# CITY OF SHELBYVILLE

## PLAN COMMISSION

MEETING DATE: 9/12/2022

PC 2022-20; 7Brew SDP			
<b>Petitioner's Name:</b>	Bill Terry, Weihe Engineering			
<b>Owner's Name:</b>	Arnold Meyer Management			
<b>Petitioner's Representative:</b>	Bill Terry, Weihe Engineering			
<b>Address of Property:</b>	2424 E SR 44			
<b>Subject Property Zoning Classification:</b>	BH – Business Highway			
<b>Comprehensive Future Land use:</b>	Gateway / Mixed Use			
	<b>North</b>	<b>East</b>	<b>South</b>	<b>West</b>
<b>Surrounding Properties' Zoning Classifications:</b>	BH – Business Highway	BH – Business Highway	BH – Business Highway	BH – Business Highway
<b>Surrounding Properties' Comprehensive Future Land Use</b>	Gateway/ Mixed Use	Gateway/ Mixed Use	Gateway/ Mixed Use	Gateway/ Mixed Use
<b>History:</b>	This site was previously a Rally's restaurant, constructed in 2007, but has since closed and sat abandoned.			
<b>Vicinity Map:</b>				
<b>Action Requested:</b>	Site Development Plan approval for a new, drive-thru only, coffee shop.

**A2.1**  
EXTERIOR ELEVATIONS  
8 July 2022 - PERMIT

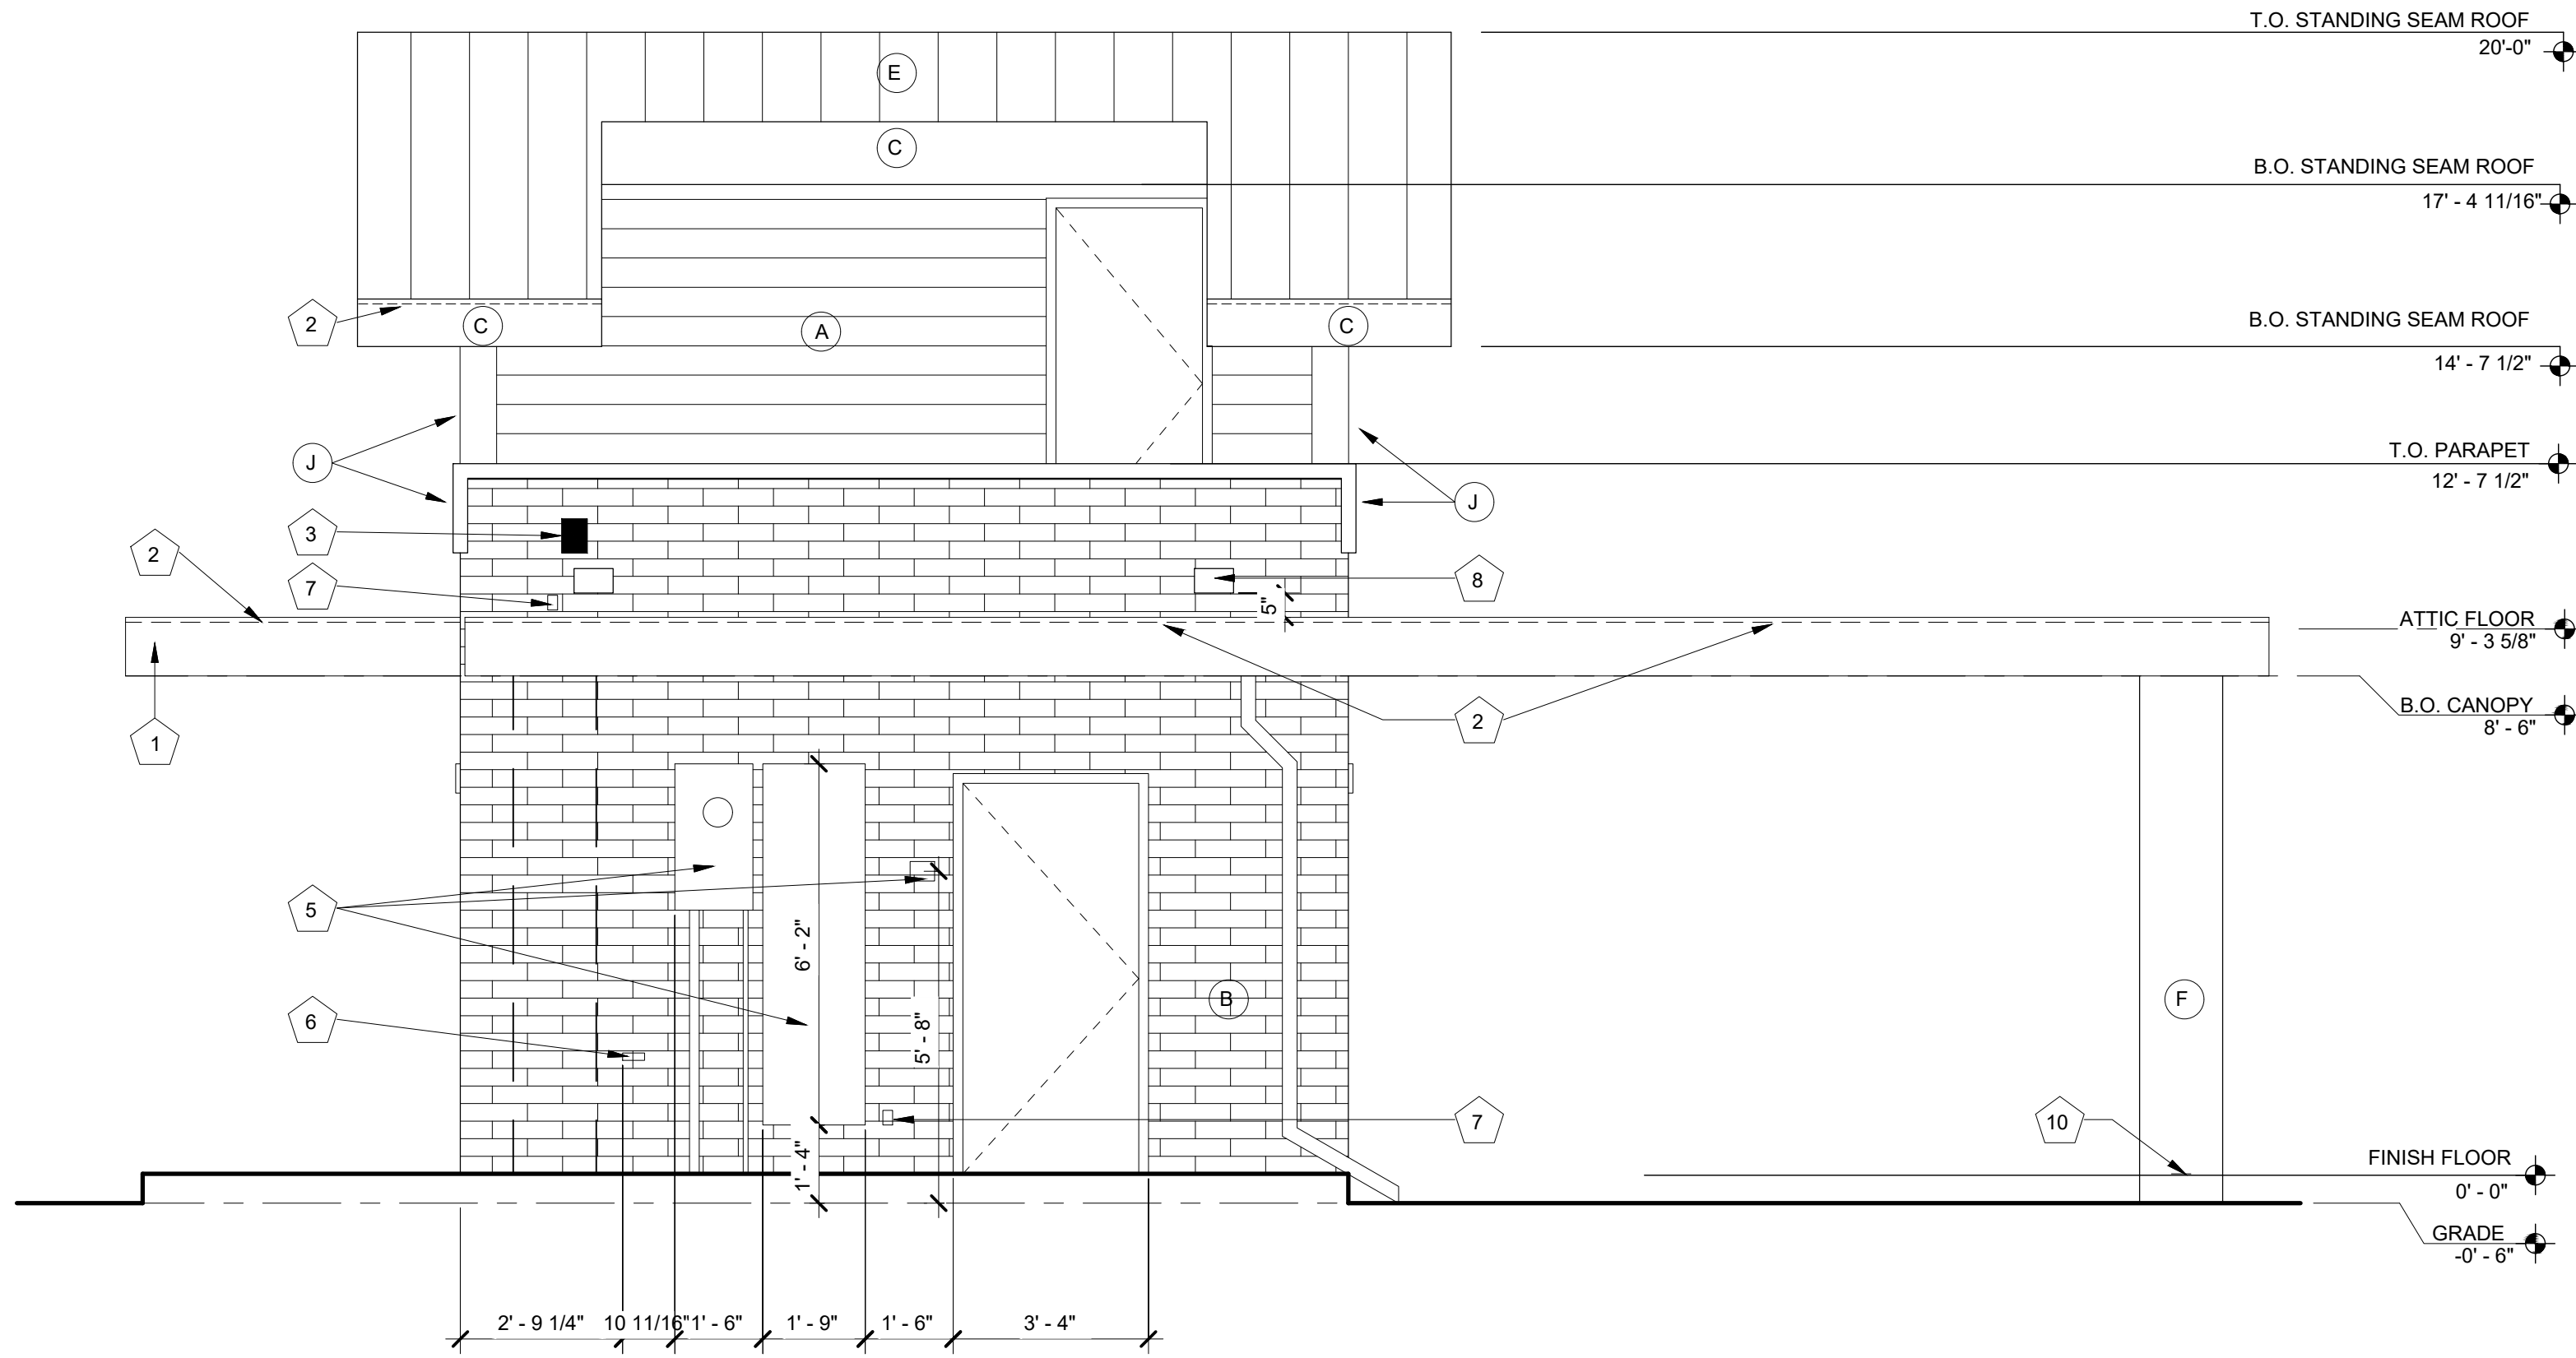
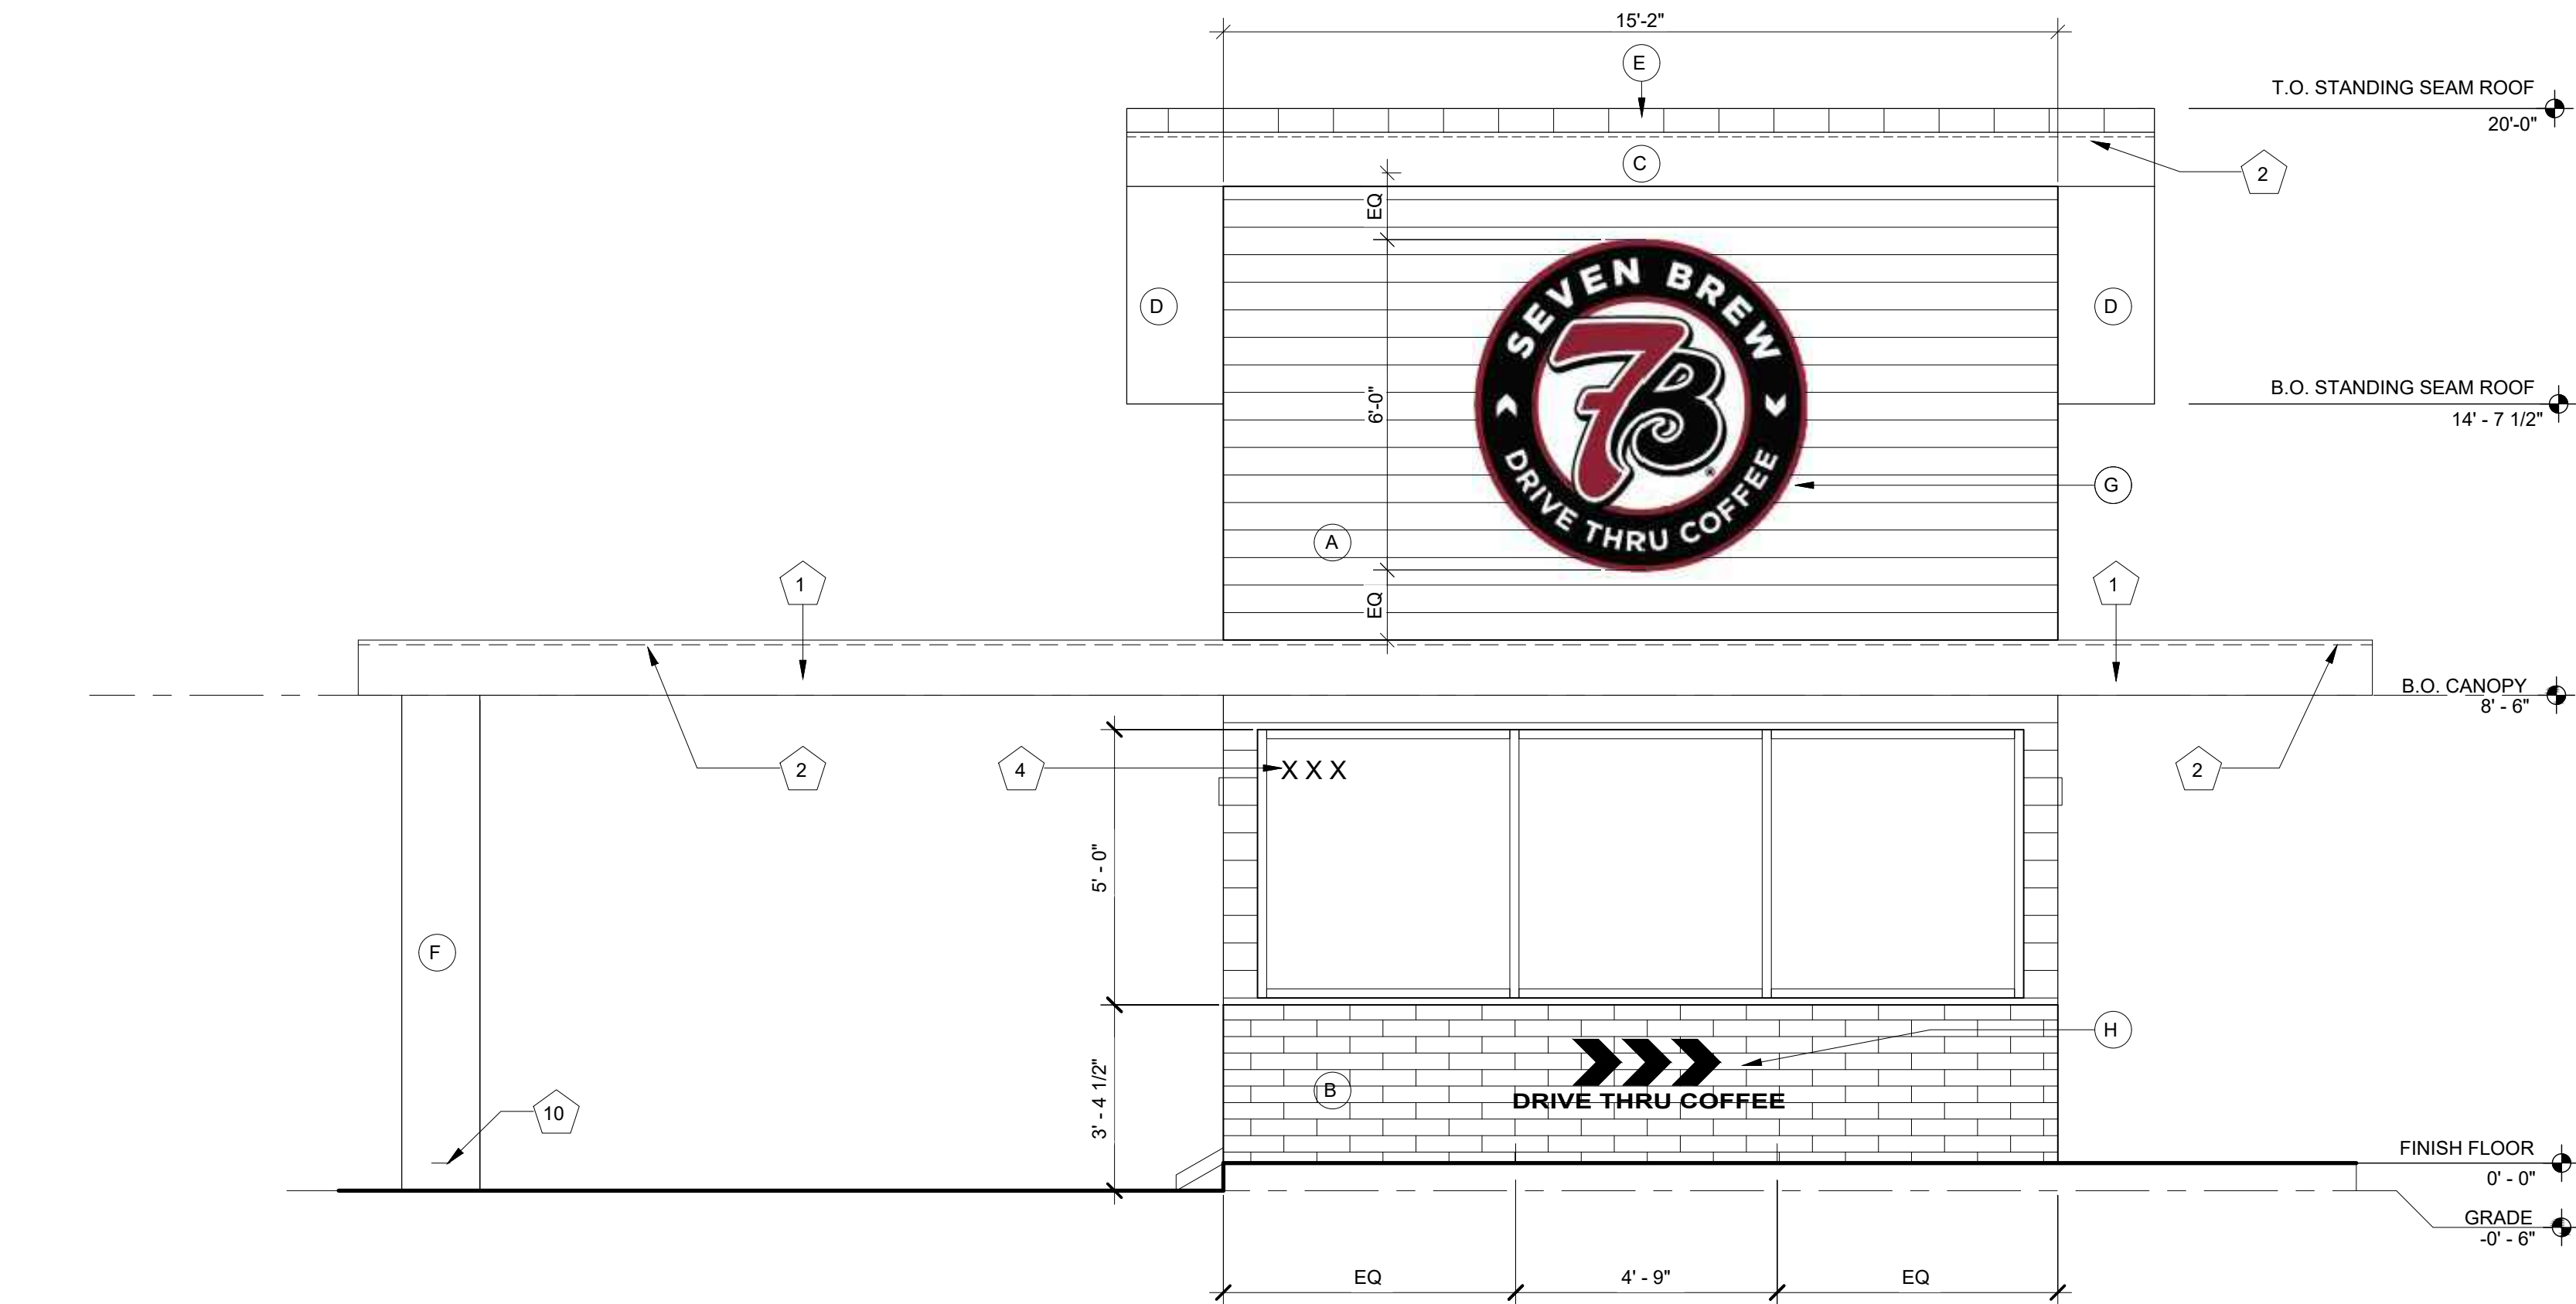
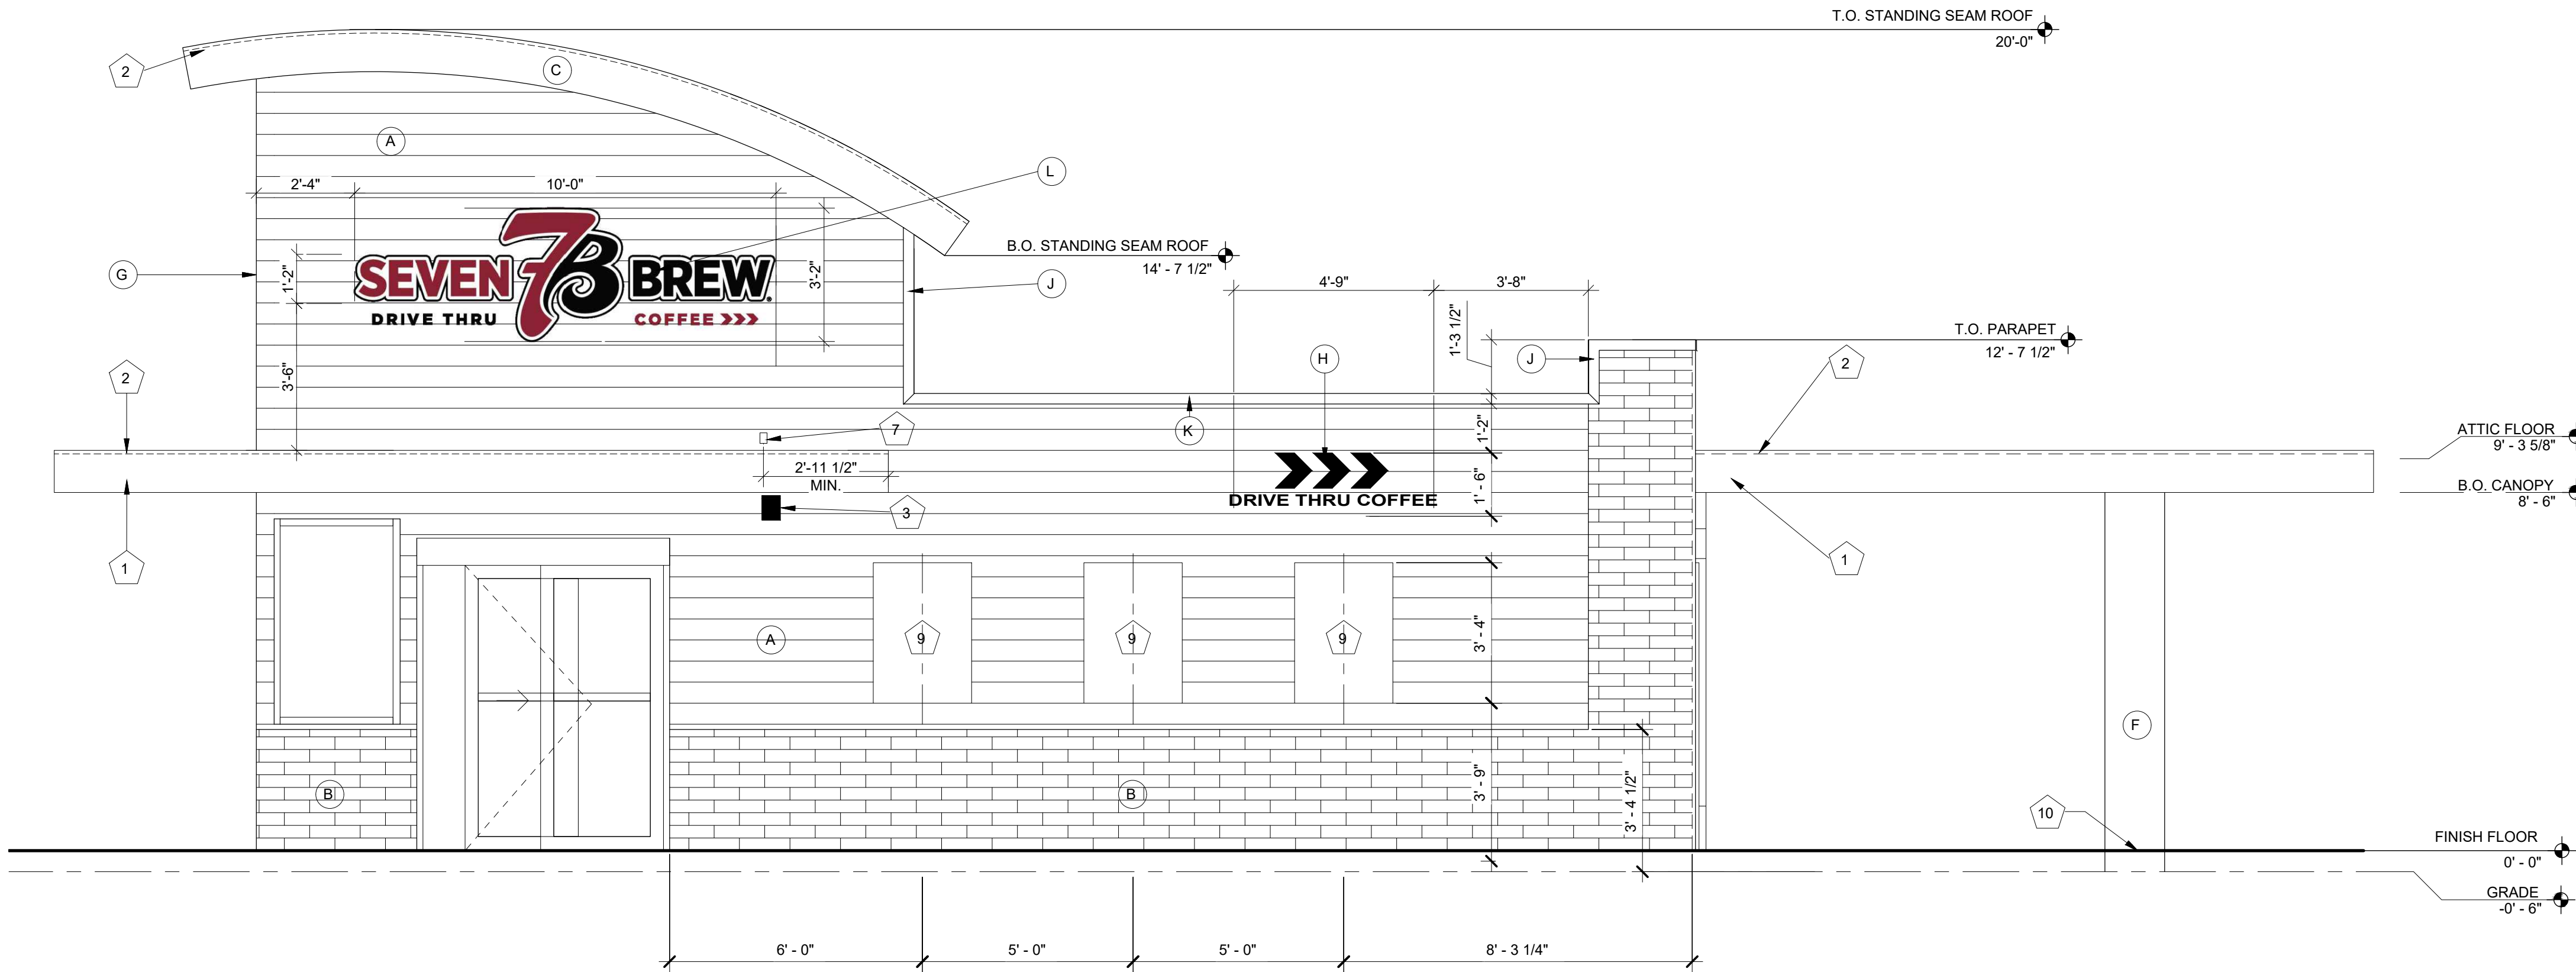
The roof contains a sloping roof on the south side of the building and a partial parapet on the north side of the building, but to satisfy this requirement the parapet will need to be extended around the east and west sides of the structure. The parapet will also need to include a three-dimensional cornice feature.

**Petitioner should submit revised plans to the planning staff with these corrections to the building's roof architectural features.**

1. Petitioner must submit revised building elevations to planning staff for review and approval to address comments regarding the Architectural Roof Elements outlined in this staff report.
